# **SSTOM – Orchard Hills Stabling and Maintenance Facility**

**Construction Traffic Management Plan**

Document no. SMWSASSM-PLD-1NL-NL000-TF-PLN-000001

Version Rev B

FIGURE 2: CRASH MAP

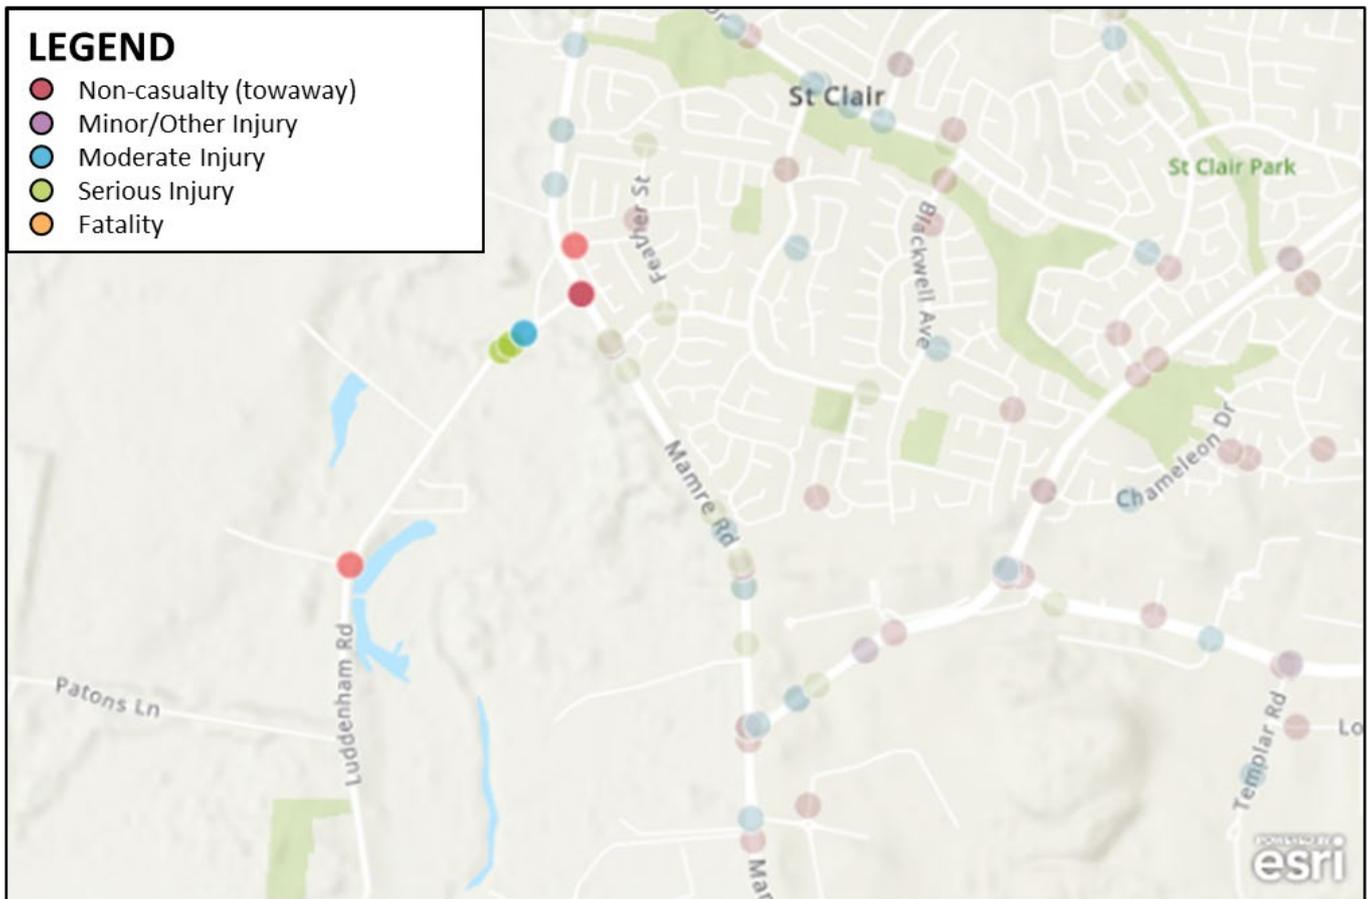
15	19/06/2023	TFN	JHODDER	SMWSASSM-PLD-1NL-NL000-TF-PLN-000001	3.4.2	NA	Crash map does not have a legend, nor is it very clear.	Observation		N
	5/07/2023	PLD	WZHENG	SMWSASSM-PLD-1NL-NL000-TF-PLN-000001	3.4.2	NA	Crash map in Figure 2 is now updated with a legend and resized for clarity.	Observation		N
16	19/06/2023	TFN	FLARUE	SMWSASSM-PLD-1NL-NL000-TF-PLN-000001	3.4.3	NA	Important to note that while Mamre Rd may not have a formal path, there are informal links to the nearest side streets or paths especially in and around the bus stops. If you are to say 'No' then there does need to be some justification or some evidence to support the claim.	Observation		N
	5/07/2023	PLD	WZHENG	SMWSASSM-PLD-1NL-NL000-TF-PLN-000001	3.4.3	NA	Section 5.2 has been updated to acknowledge the informal links on Mamre Road and a Driver's Code of Conduct has been added in Appendix F to enforce driver behaviour.	Observation		N

FIGURE 4: SMF STAGE 01 ARCHITECTURAL (PRELIMINARY)

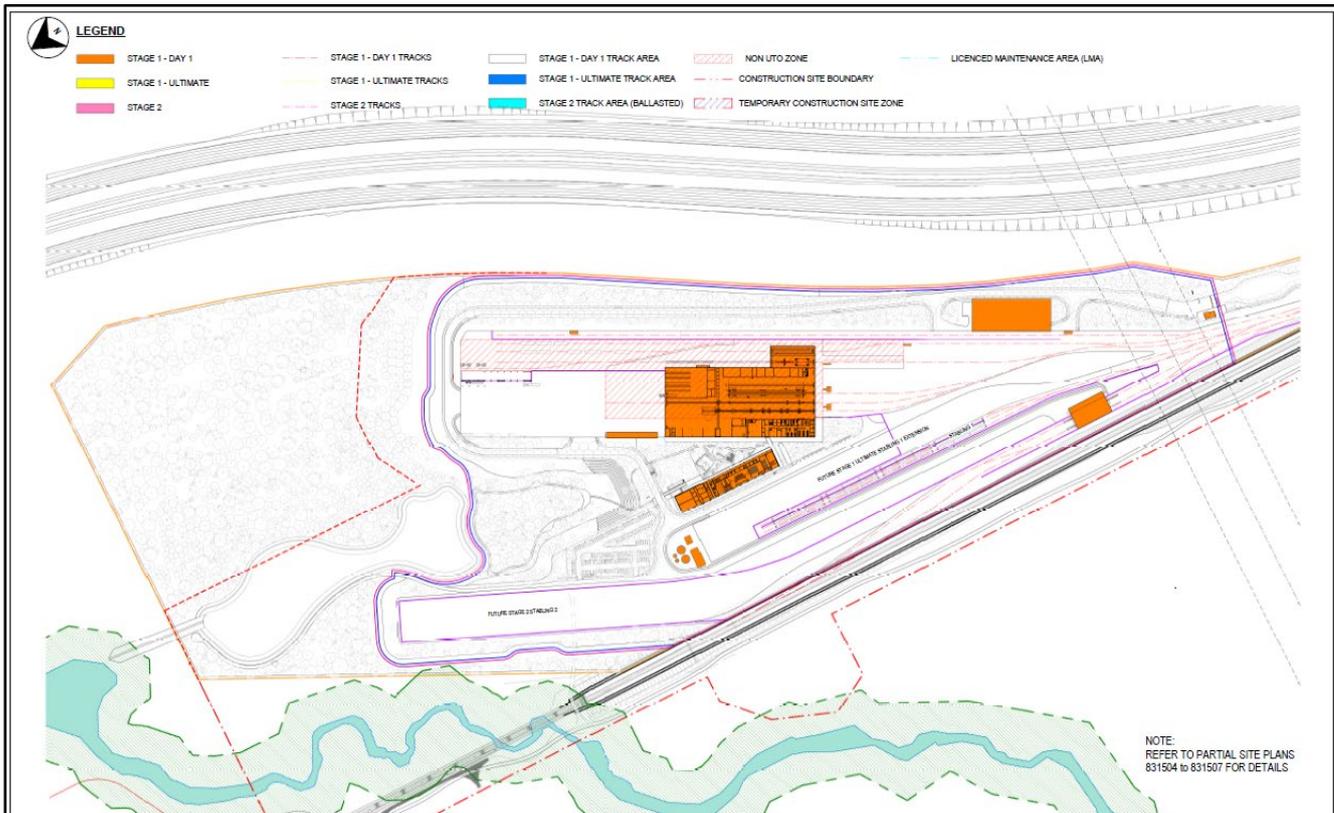
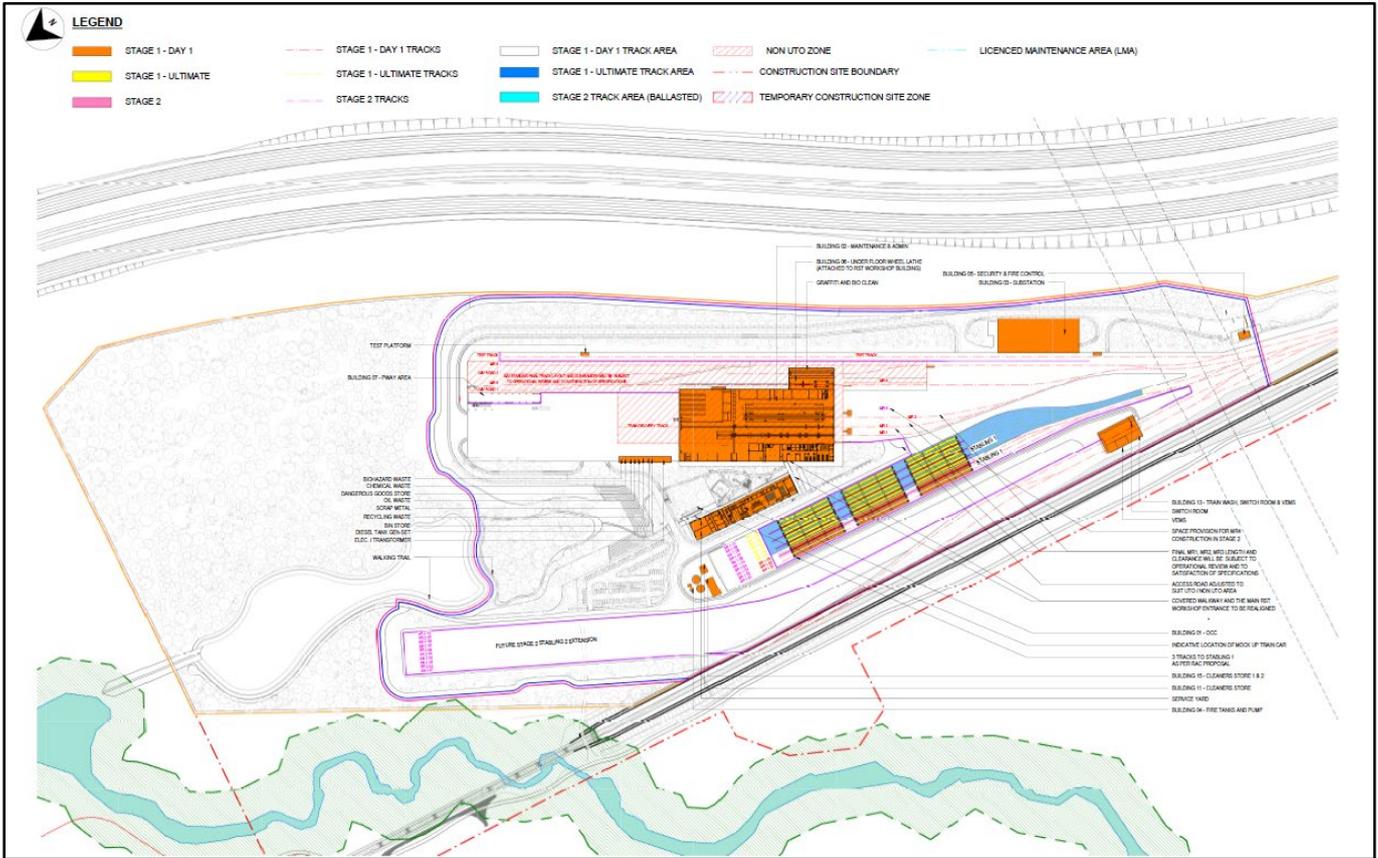
02	7/06/2023	SMD	PBROGAN	SMWSASSM-PLD-1NL-NL000-TF-PLN-000001	Sections 4.1 and 4.2	CTMF	For Berin - the Site layout drawings in Section 4.1 and 4.2 do not provide street names or context. The CTMP is to provide detail on how traffic will be managed, at the site, during construction, during a time. These drawings are great for context but need to be updated to show how the site will operate day to day.	Actual Non-Compliance		N
	5/07/2023	PLD	WZHENG	SMWSASSM-PLD-1NL-NL000-TF-PLN-000001	Sections 4.1 and 4.2	CTMF	Sections 4.1 and 4.2 are for site specific project context. Section 4.3 and 4.6.1 has been updated to discuss in further detail how the site access is being managed and the TGS is updated accordingly.	Actual Non-Compliance		N
03	7/06/2023	SMD	PBROGAN	SMWSASSM-PLD-1NL-NL000-TF-PLN-000001	Section 4.2	CTMF & Deed	For Berin - the Site layout drawings in Section 4.2 has a statement on it that stating it is: "preliminary", "for review and comment" and that it "should not be issued to Sydney Metro". Please provide accurate, relevant drawings.	Actual Non-Compliance		N

FIGURE 8: SMF STAGE 01 ACCESS SET UP

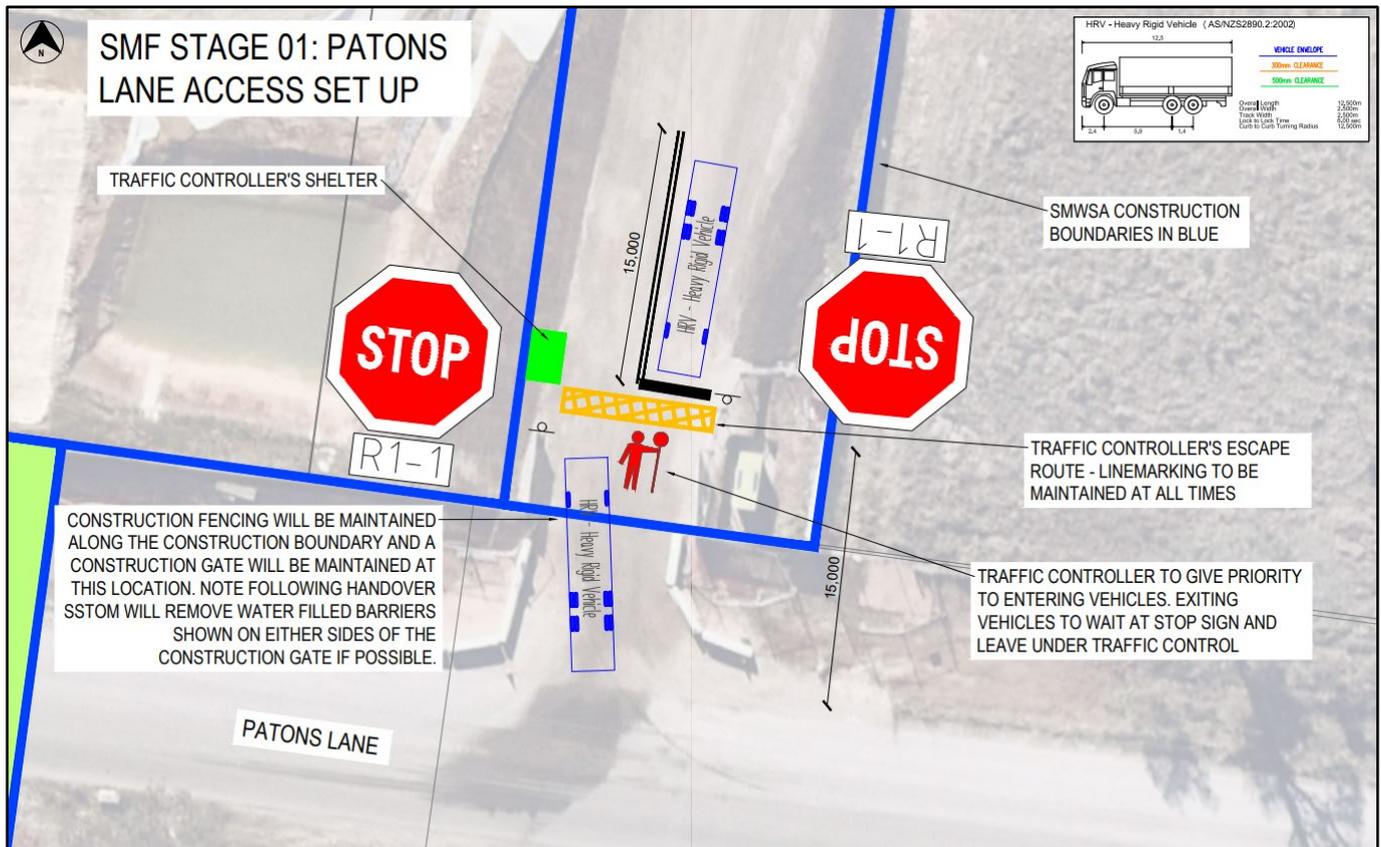
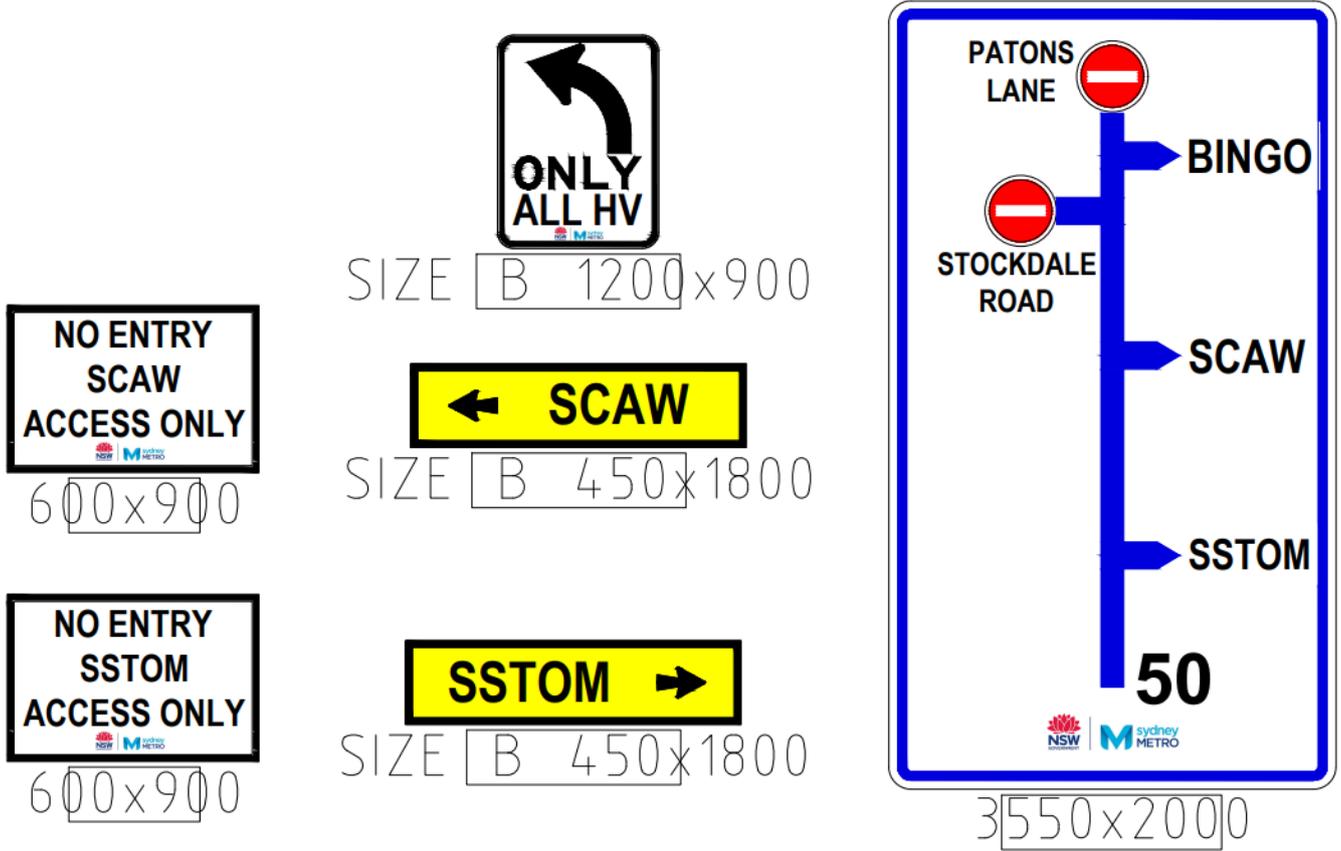
05/07/2023	4.6.1	New text. Figures 8 and 9 have been replaced.	<p>Due to the utility box located at the site access to SMF, the construction driveway width for SSTOM is too narrow to allow comfortable simultaneous access for two HRVs. To ensure queuing on Patons Lane is minimised, traffic controller at the Patons Lane gate will give priority to entering vehicles at all times and the set up in Figure 8 will be implemented for Stage 01 works.</p> <p>All vehicles accessing the SSTOM will have to register on the PLM logistics software for a timeslot on site. If a vehicle arrives early or late and there is no delivery slots immediately available, vehicles will be directed to queue on the shoulder of the access road which is one kilometre long between gate and SMF site.</p> <p>External to the site, to mitigate the confusion of having the SSTOM, Linewide, SCAW and BINGO accesses all within 150m of each other, an advance direction (diagrammatic type) sign will be installed on Patons Lane after the Endeavour Energy site for wayfinding purposes. Additional wayfinding signage will be installed adjacent to the SSTOM and SCAW site gates to notify and reinforce the different construction accesses. PLM is currently liaising with BINGO regarding SSTOM site start up as</p>
